Confederated Tribes and Bands
of the Yakama Nation

RE: Opposition to LIHI Certification for the Wells Hydroelectric Project

Technical Attachment A: Assessment of Wells Dam Compliance with LIHI Certification Criteria

Figure 1: Comparison between adjusted dam counts at Priest Rapids Dam (circles) and summed estimates of the four Upper Columbia Steelheads populations plus estimates of Steelheads overshoots at Priest Rapids Dam. Whiskers represent 95% confidence intervals of those sums (Murdoch et al. 2022).

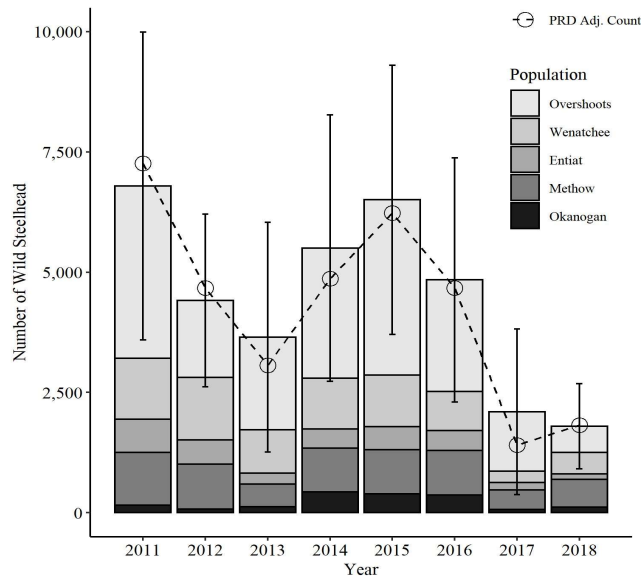
A substantial number of adult Steelhead from ESA-listed downstream populations, particularly the Snake and Yakima Rivers, overshoot their natal tributaries and migrate upstream into the Upper Columbia, often passing upstream of Wells Dam. This ‘overshoot behavior’ has been documented for nearly two decades (Richens and Skalski 2018), but only recently has the full scope and magnitude been quantified. Murdoch et al. (2022) estimated that 426 to 3,048 wild overshoot Steelhead enter the Upper Columbia every year, with Wells Dam being the second most common final detection point (after Priest Rapids Dam). Figure 1 illustrates the scale of overshoot behavior relative to dam counts and local population estimates.

Figure 2: Downstream migration of radio-tagged overshoot Steelhead (n=165) (Fuchs et al. 2021) and the percentage that migrated during juvenile spill periods, 2015-2016 (note: The Priest Rapids Project provides steelhead fallback spill through mid-November).

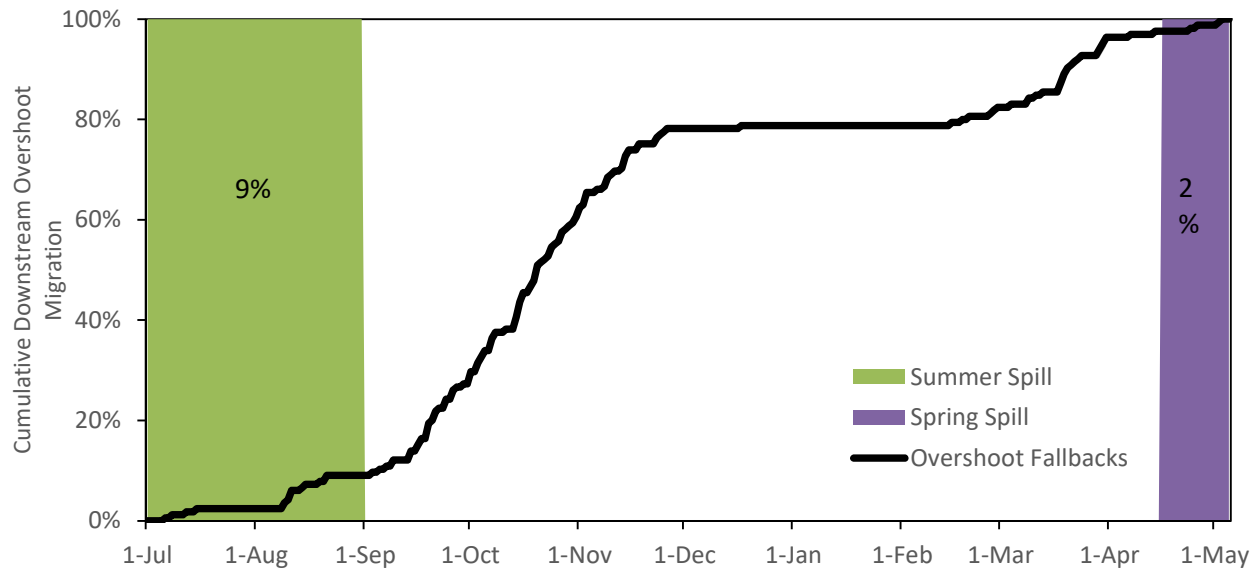
Wells Dam presents a substantial hazard to these overshoot fish because no downstream surface passage route is provided to support their return migration. Overshoot Steelhead attempting to return downstream do so in the fall or early spring, periods (Figure 2) when juvenile spill operations are no longer in effect and turbine passage is the only downstream route available.

Figure 3: Points depict the percentage of overshoot Steelhead into the Upper Columbia which successfully returned to natal tributaries; Dams 1 & 2 = Priest Rapids Project, 3= Rock Island Dam, 4=Rocky Reach Dam, and 5=Wells Dam (Murdoch et al. 2022).

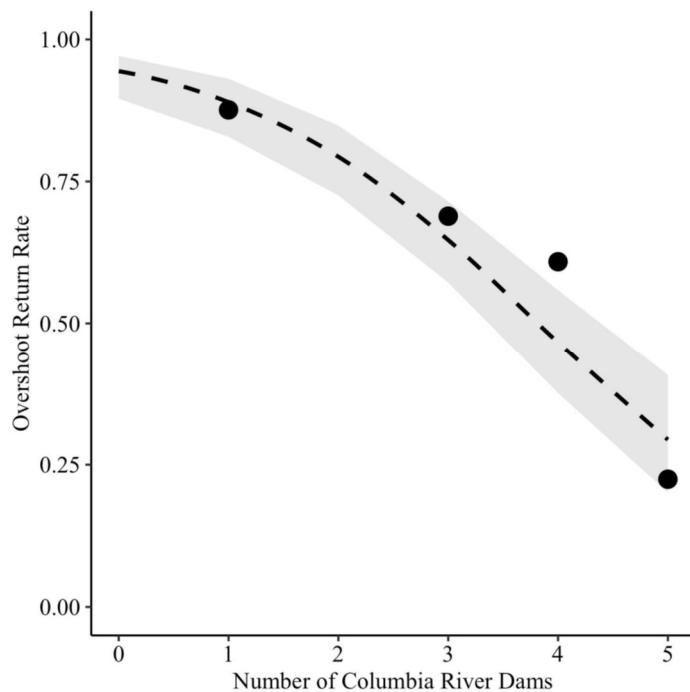
Radio-telemetry studies confirm that most overshoot fish attempt to fallback between September and late November (Fuchs et al. 2021; Figure 2). While the Priest Rapids Project (Priest Rapids and Wanapum Dams) provides 24/7 fallback spill through mid-November, enabling high rates of return, Wells Dam does not. At Wells, fallback success drops steeply. Fewer than 25% of overshoot Steelhead that migrate above Wells successfully return to their natal tributaries (Murdoch et al. 2022; Figure 3).

Figure 4: Annual rates of iteroparity in wild Upper Columbia Steelhead sampled at Priest Rapids Dam during HCP implementation, 2000-2021 (data provided by WDFW).

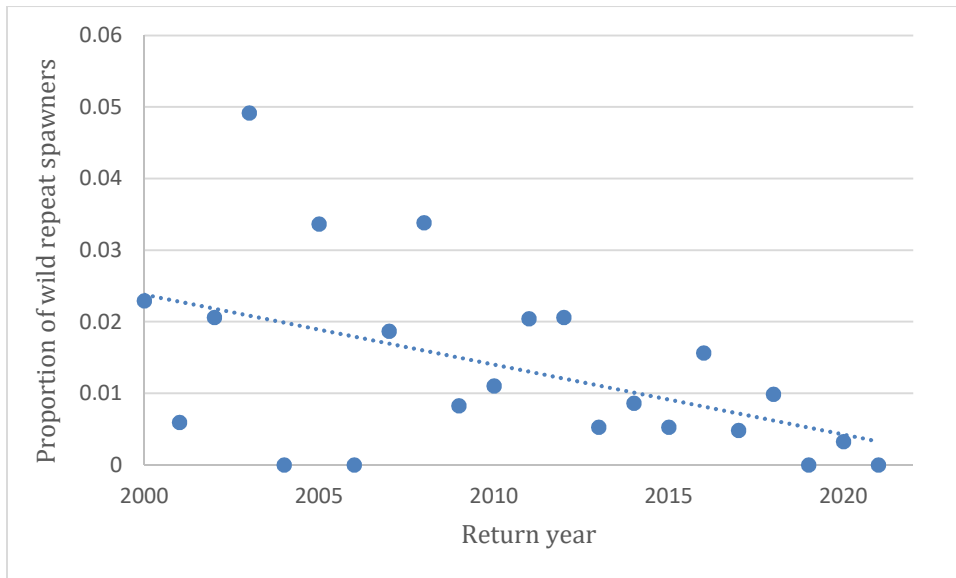
If kelt survival has indeed improved as a result of HCP measures at the Wells Project, we would expect an increase in the proportion of repeat spawners in the Upper Columbia. Trends of repeat spawning based on fish scale pattern analysis of wild Steelhead sampled at Priest Rapids Dam indicate the

opposite, a downward trend in iteroparity during the 23 years of HCP implementation relative to first time spawners (Figure 4).

Although the data we present on declining rates of iteroparity encompass the entire Upper Columbia region, including Wells, Rocky Reach, Rock Island, Wanapum and Priest Rapids dams, this broader geographic scope should not dilute the accountability of individual projects. These facilities operate under very similar HCP and Settlement Agreements, affect the same ESA-listed Steelhead populations, and impose cumulative impacts on downstream-migrating adult fish. The lack of measurable improvement in kelt survival and iteroparity trends across two decades of HCP implementation underscore a systemic failure that extends beyond a single project. Certifying the Wells Project as low impact under these conditions would not only ignore those biological realities but would also set a damaging precedent for other PUD projects that have similarly neglected adult downstream passage (for both overshooting steelhead and kelts). Such a precedent would signal that failure to monitor or improve conditions for adult Steelhead, even when feasible, remains compatible with a “low impact” designation. The Yakama Nation urges LIHI to reject that interpretation and instead uphold its criteria by requiring project-specific accountability for downstream adult Steelhead survival.

Figure 5: Mean migration timing of Wenatchee wild Spring Chinook at the lower Wenatchee smolt trap and mean Columbia River water temperatures, 2013-2022. Gray shaded area denotes Spring spill at Rock Island Dam (ISAB 2018).

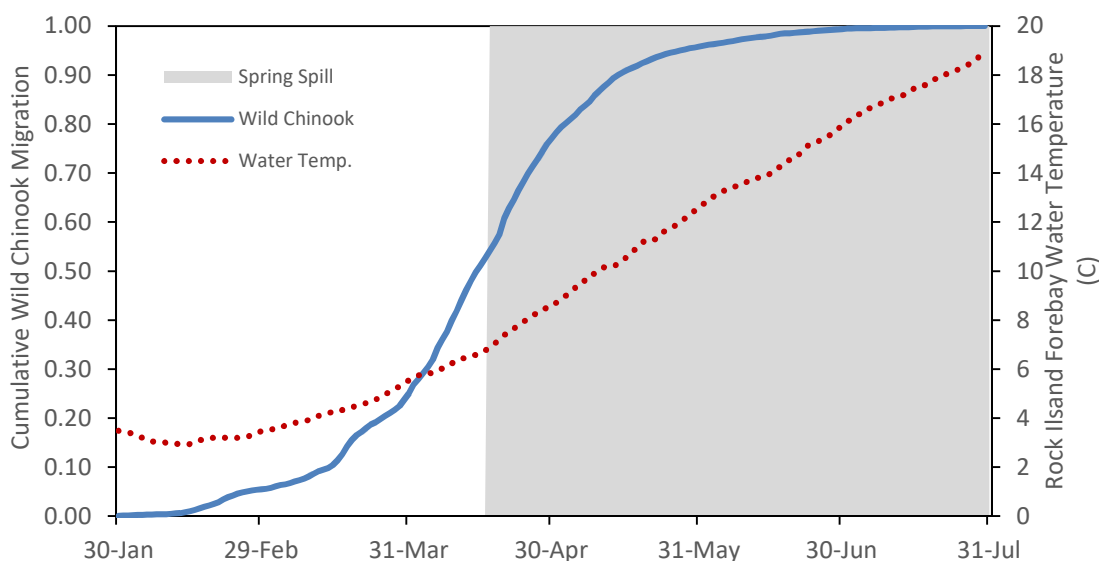
Unlike hatchery fish, wild Spring Chinook smolts lack a fixed release date and begin downstream migration in late winter and early Spring, over a broad timeframe. Wild smolt run timing from the Wenatchee and Entiat Rivers indicates that a significant portion of wild Spring Chinook smolts (up to 60%) are migrating before the start of spill in the Upper Columbia River (Figure 5). Unfortunately monitoring infrastructure to provide similar information for Methow Spring Chinook migrating into the Wells Project Area does not exist, however, we have no reason to believe the migration timing of Methow Spring Chinook would be any different from than that of Wenatchee or Entiat River Spring Chinook.

Douglas PUD does not currently monitor wild fish run timing into or through the Wells Project. Present day migration timing estimates are generated indirectly based on sampling downstream at Rocky Reach Dam and the Program RealTime forecaster (DCPUD 2025). These methods only provide a retrospective approximation, of primarily hatchery fish run-timing and have limited utility for real-time protective measures for wild migrants.

Figure 6: Cumulative run timing curve based on wild Spring Chinook PIT tag detections at Rocky reach Dam in 2024.

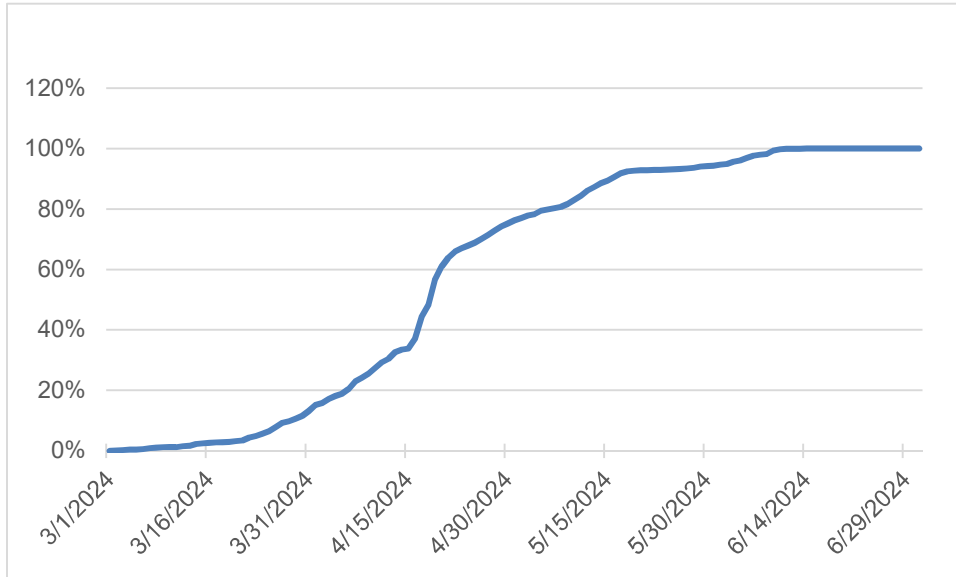
While we don't have empirical data from Wells Dam due to lack of monitoring infrastructure and PIT tag detection. We do have some information from the Rocky Reach surface collector and bypass. In 2024, Chelan PUD implemented an early bypass evaluation at Rocky Reach Dam starting March 1, to fulfill their HCPs run timing evaluation requirement (Douglas PUD has a similar yet currently unfulfilled requirement). From March 1 to July 1, 931 wild Spring Chinook PIT tags were detected at Rocky Reach Dam: 39% from the Entiat and 61% from the Methow population. Fish migrating from the Methow River already passed through Wells Dam before detection further downstream at Rocky Reach Dam. Given the 148-161 km distance from upstream tagging sites, cold temperatures, coupled with low March river flows, fish travel time was likely lengthy; even so, 30% of all PIT tagged wild Spring Chinook from the

Methow River still passed Rocky Reach prior to April 15th (Figure 6). This indicates that a significant portion of the wild Spring Chinook population also migrate past Wells Dam in advance of spill and bypass operations.

Figure 7. Estimates of survival from release to McNary Dam for wild (red) and hatchery (green) Chinook salmon smolts from the Wenatchee Basin as presented at the 2024 Upper Columbia Science Conference (Chasco and Murdoch 2024)

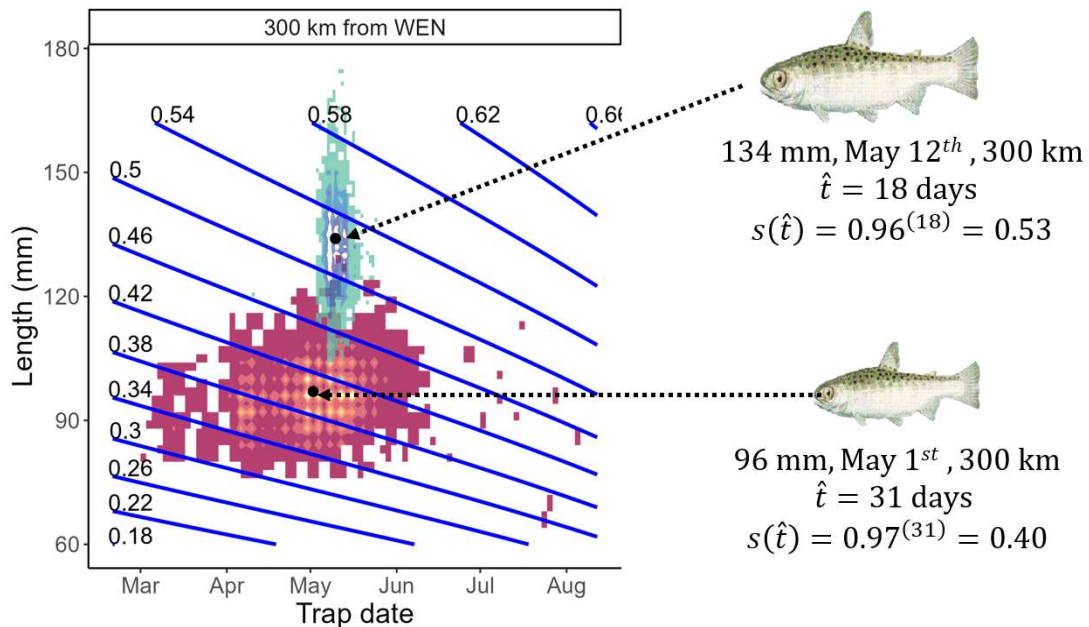
Recent modeling by Chasco and Murdoch (2024) further shows that survival estimates generated from larger, later migrating hatchery fish can overestimate survival (Figure 7). Their PIT tag based analysis of Wenatchee Chinook demonstrates that both fish size and fish travel time had substantial effects on survival, reinforcing the need for studies that reflect the full range of migration conditions.

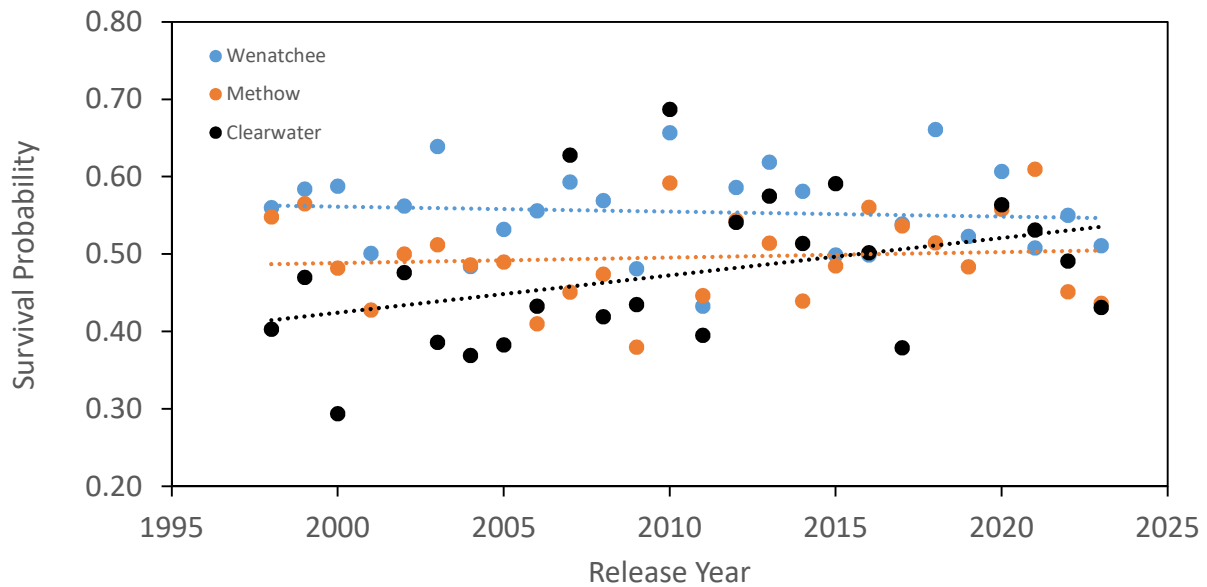
In contrast, over the same time period, smolt survival in the Snake River, has shown a gradual upward trend (Figure 5), demonstrating system wide improvements are possible when meaningful actions are taken.

Figure 5 shows downstream migratory survival of Upper Columbia hatchery Spring Chinook from the Wenatchee (Leavenworth NFH) and Methow (Winthrop NFH & Methow Salmon Hatchery), and the Snake River for comparison (Dworshak NFH; Clearwater River). Despite year-to-year variability, migratory downstream survival from Upper Columbia hatchery programs has remained flat or declined, while survival through the Snake River has improved.

Figure 9: Trends in Methow wild Spring Chinook Salmon spawner abundance from 1997 to 2023. Dotted line denote linear trend. Data from Snow et al. (2024). 1999 = ESA listing; 2002 = start of Wells HCP agreement.

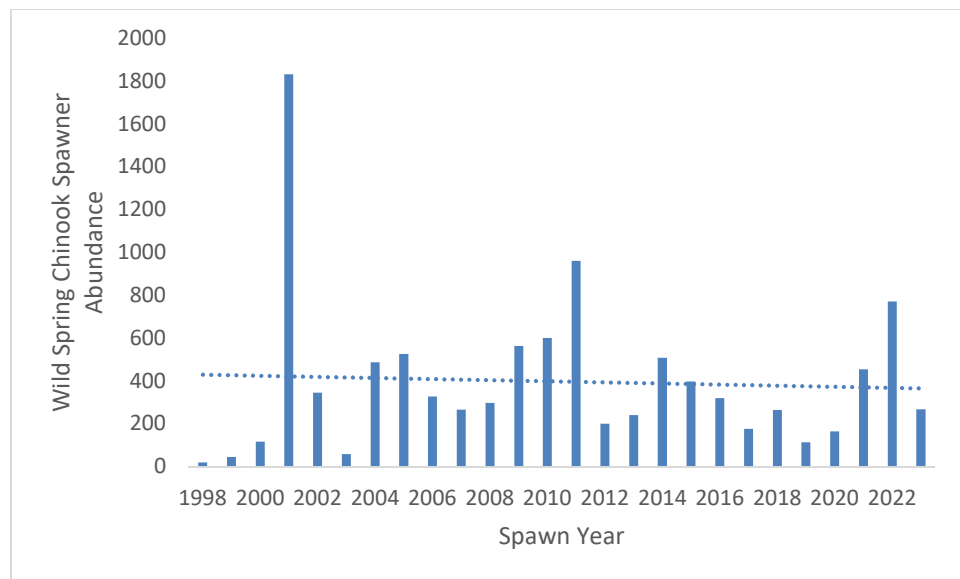
Figure 6 shows a similar long term stagnation in wild Spring Chinook spawner abundance in the Methow River from 1998 to 2023.
